CY8CKIT-032

TITLE: ww101board

REV:
2.1

Document Number: PSoC

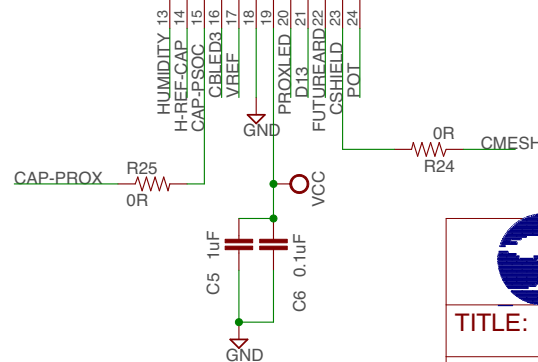
P37 should be a direct path to thermistor ground

Power

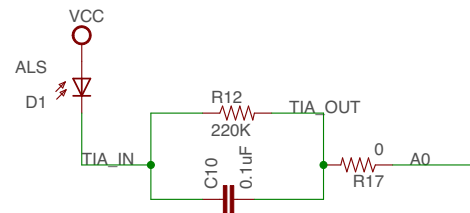
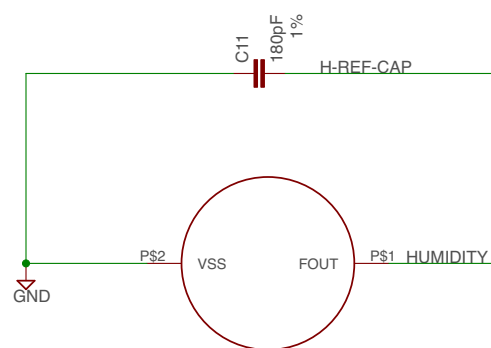
DNP - J5

It will only be used in the situation where the user has to switch back and forth between v50 and v33

If that is required they will hand solder a header into the board and remove the 0ohm resistor from R32
